DAVIS
PARTNERSHIP
ARCHITECTS

ADDENDUM NO: 03

Date Issued: December 9, 2015

**Re: Red Rocks Community College
Student Recreation Center**
Construction Documents, Dated November 9, 2015
Architect's Project No. 15803.00

S-101

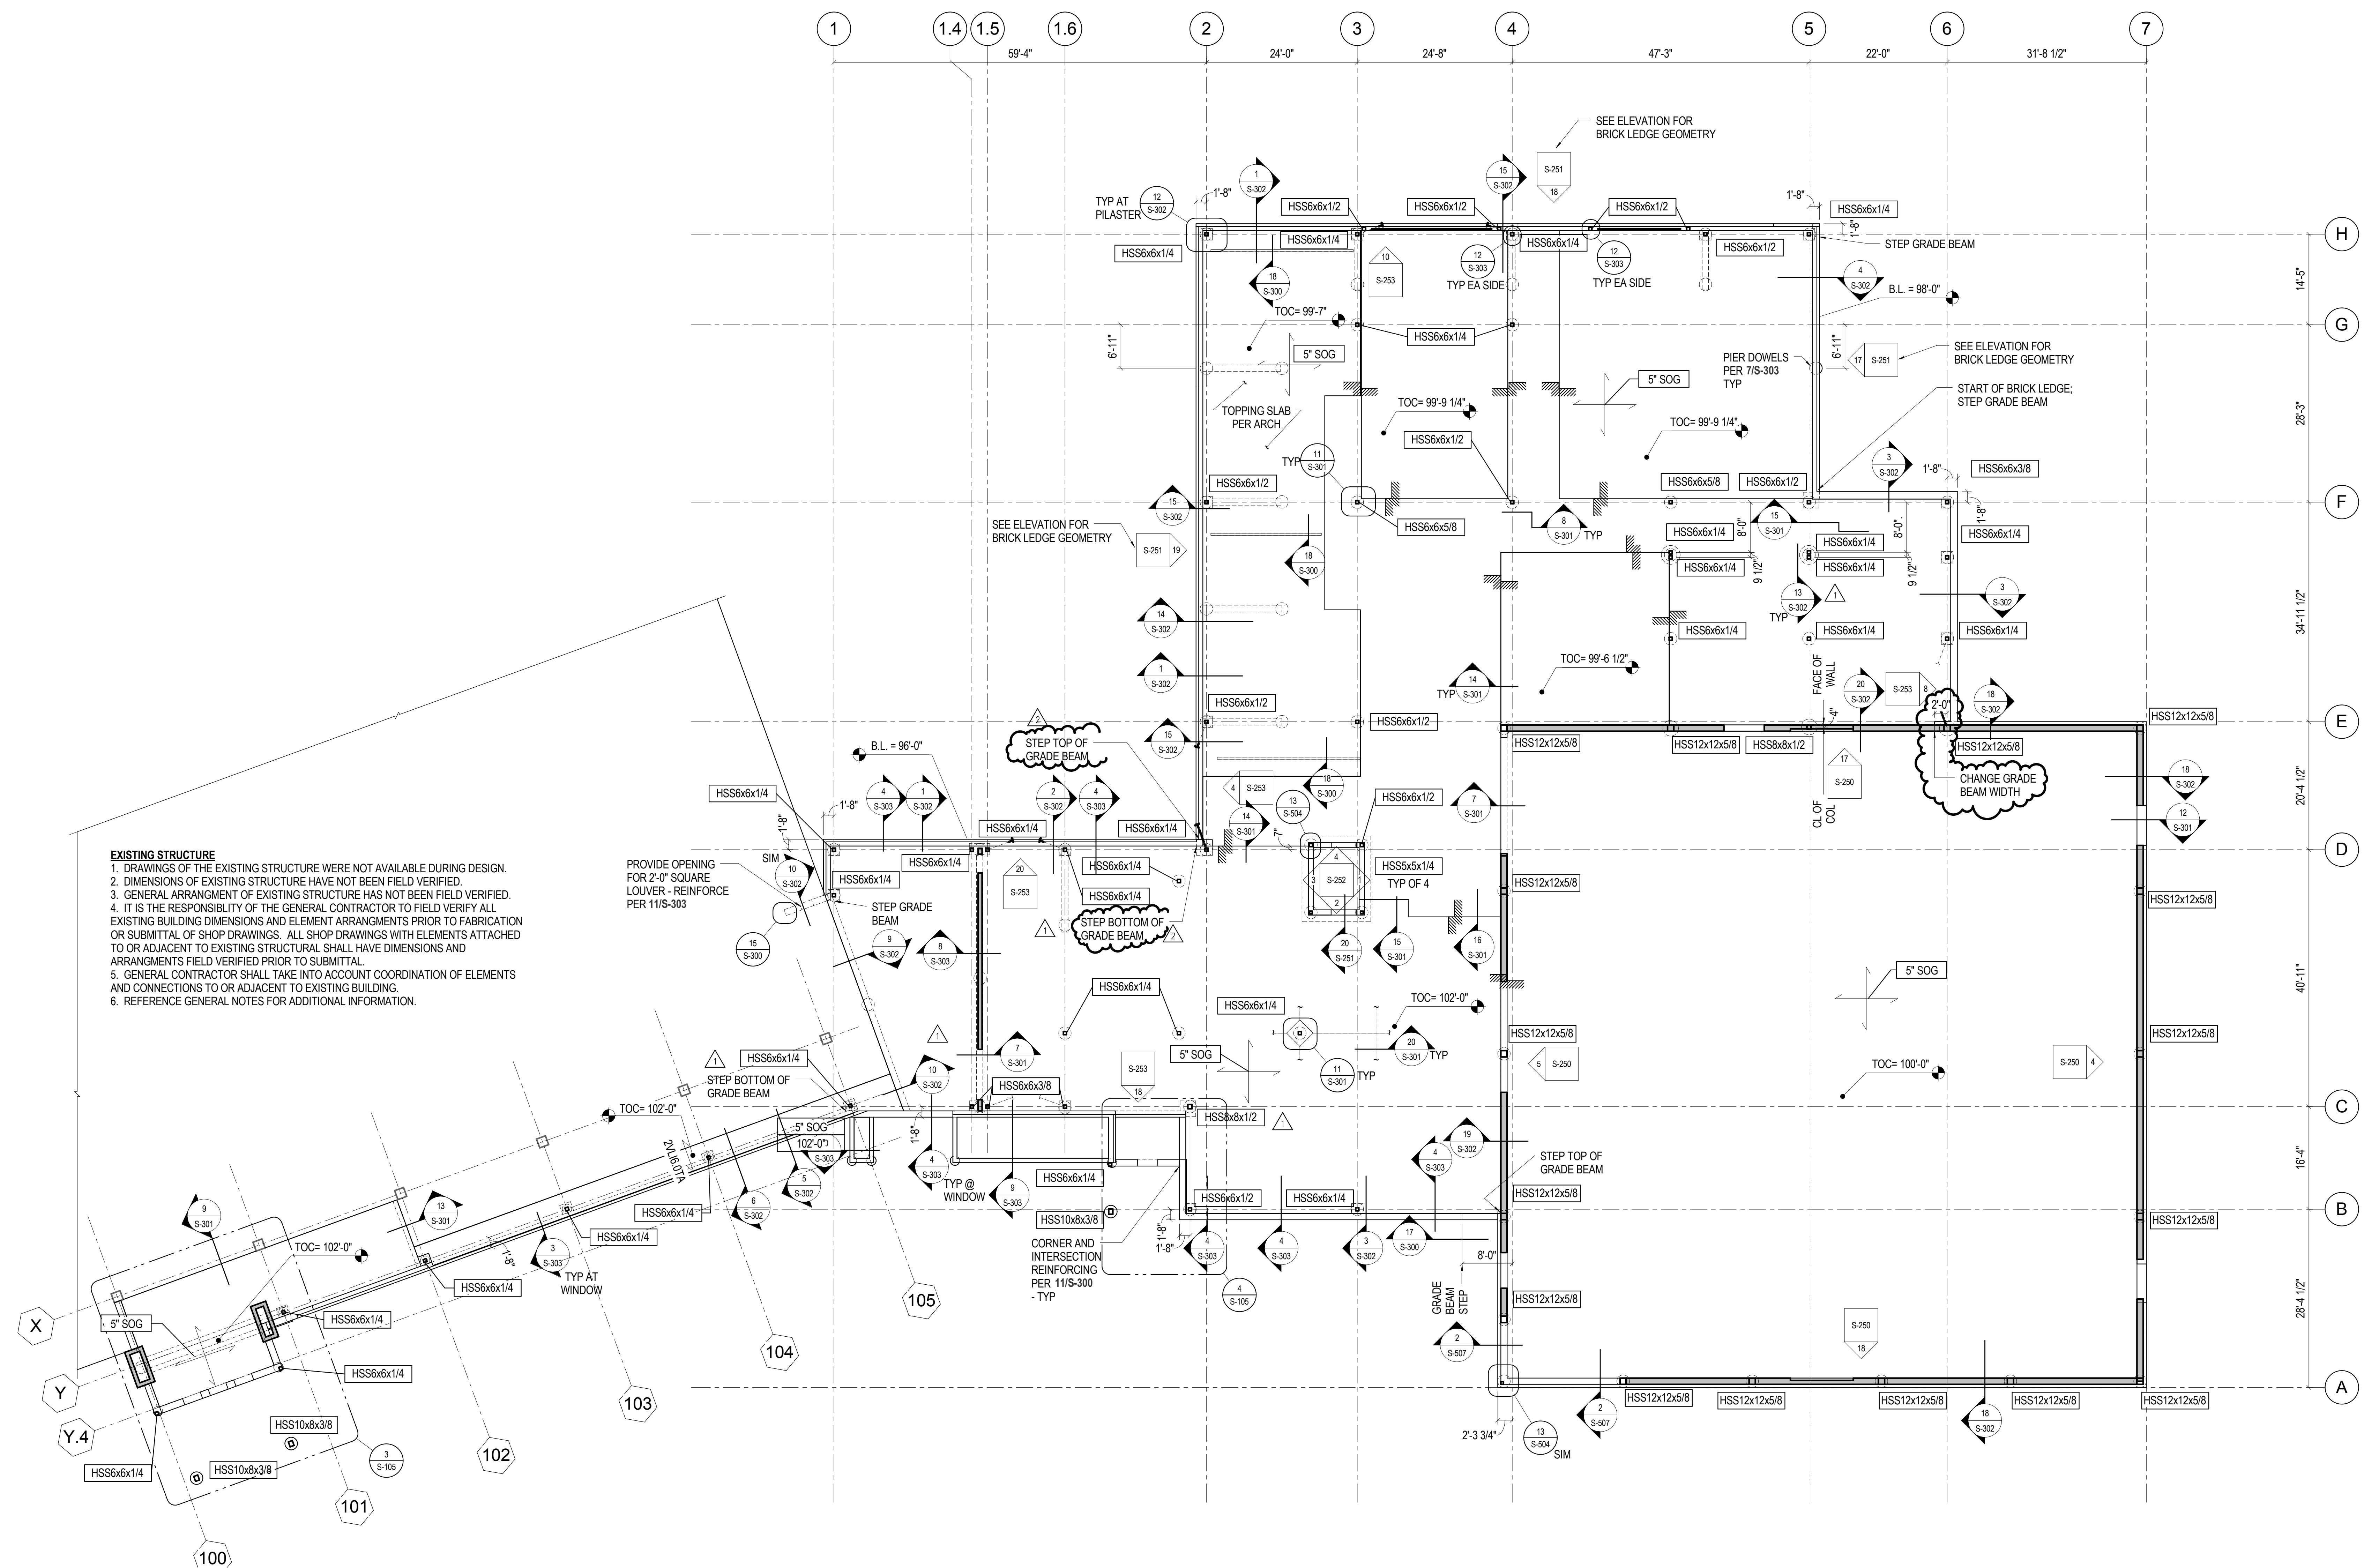
ADD. #3-60. Revised foundations:

1. S-101: Clarified grade beam step location near grids 2-D.
2. S-101: Extended wider grade beam beyond column at grids 6-E, added note and dimension.

Sheet Title:
LEVEL 2 FRAMING PLAN

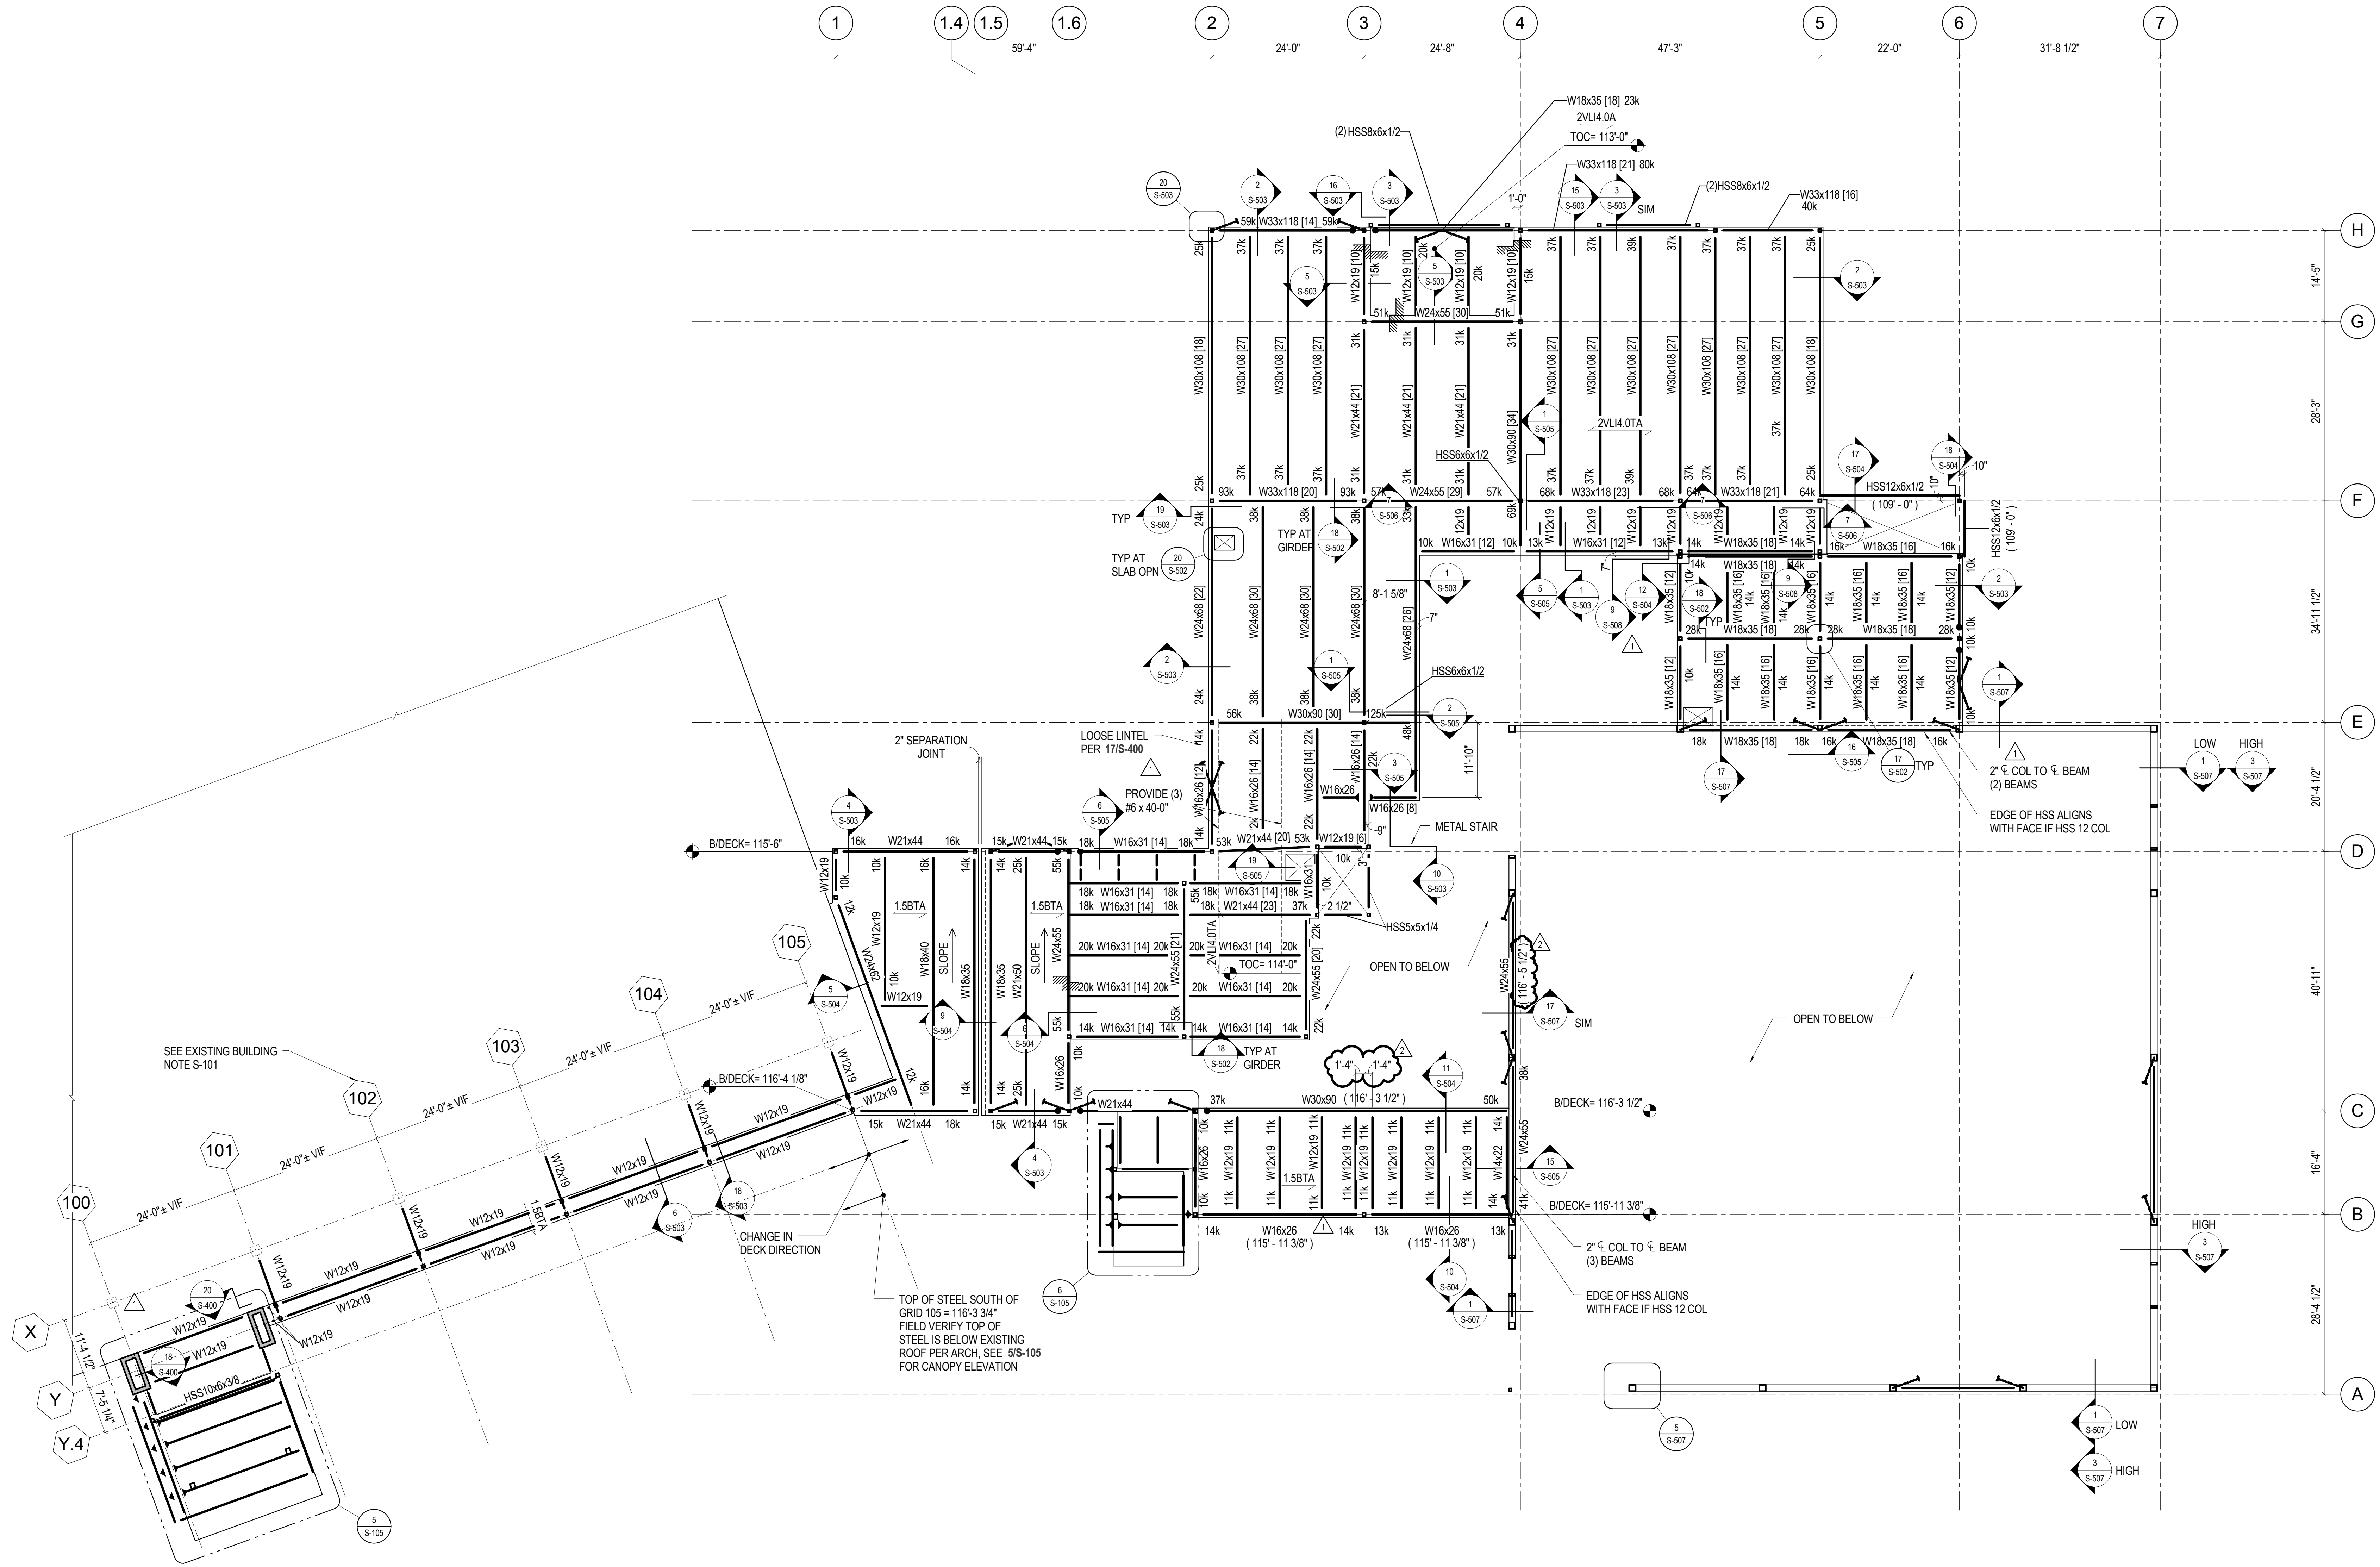
ADD. #3-61. Revised level 2 framing:

1. S-102: Added WF beam and revised framing near grid 3-B and 3C.
2. S-102: Provided top of steel elevation on grid 4.

S-103

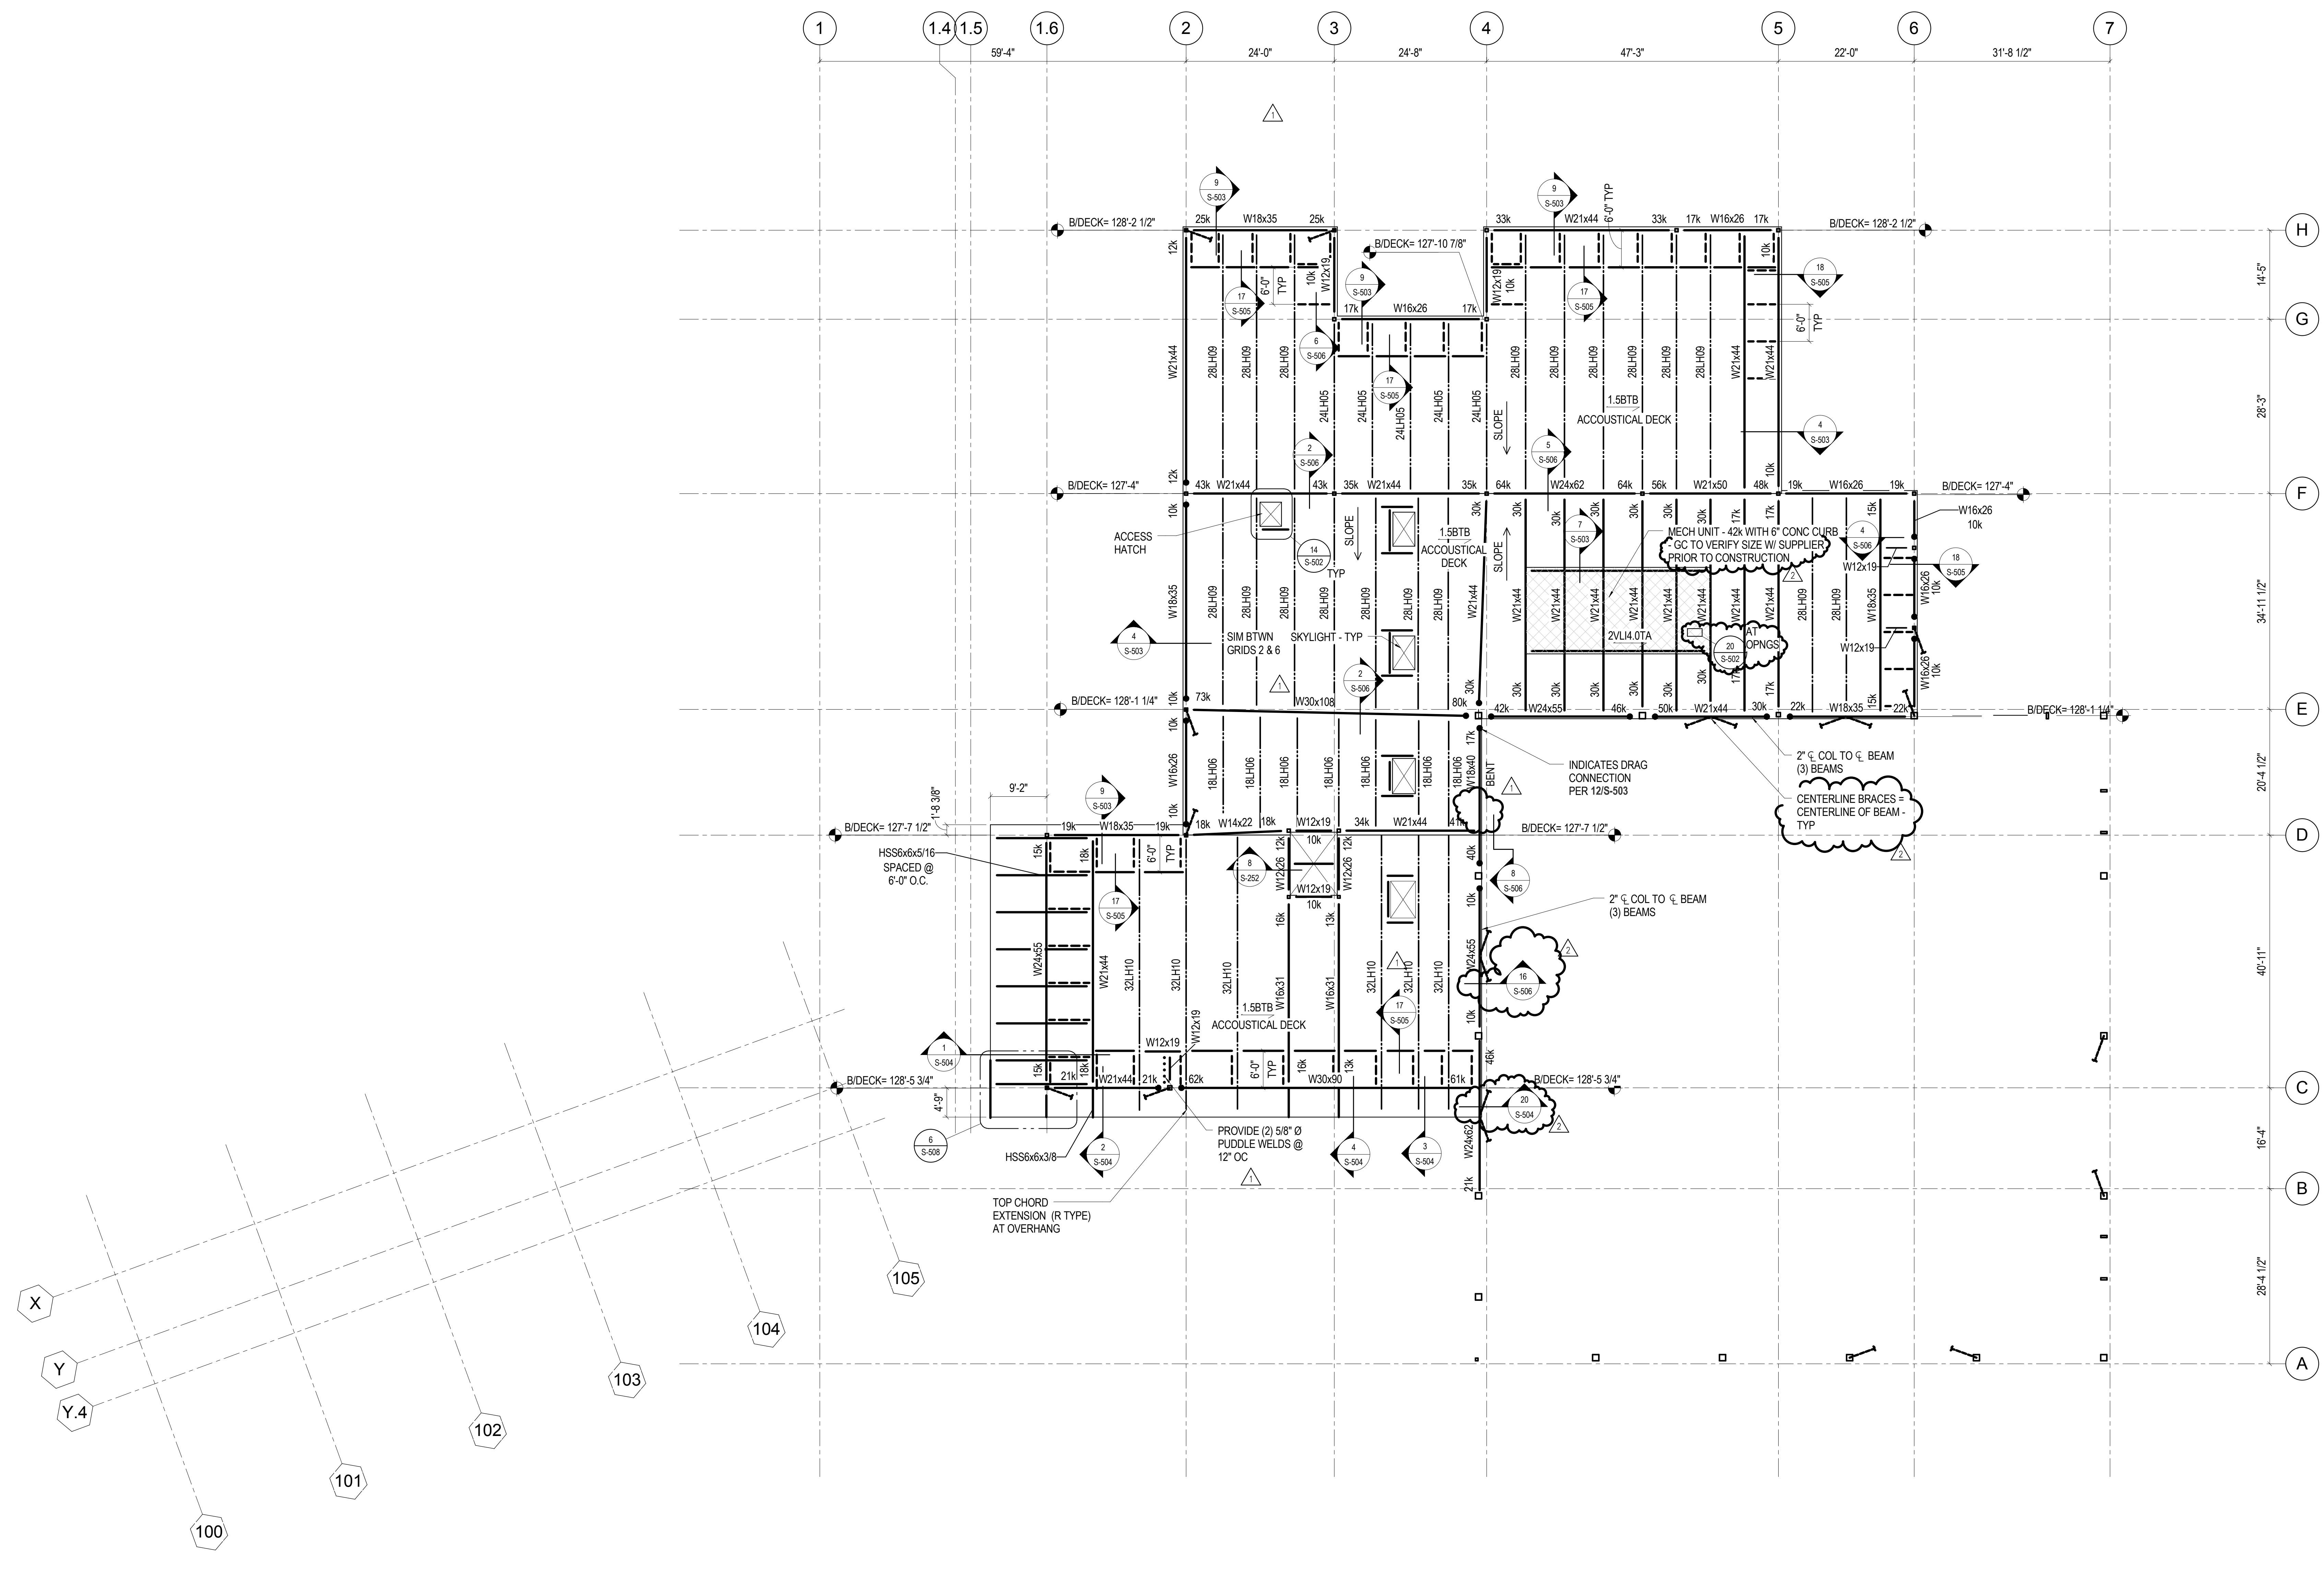
ADD. #3-62. Revised level 3 framing:

1. S-103: Added detail 20/S-504 on grid 4.
2. S-103: Moved detail 16/S-506.
3. S-103: Clarified alignment note at gym.
4. S-103: Added RTU pad size verification note.
5. S-103: Added opening detail at RTU pad.
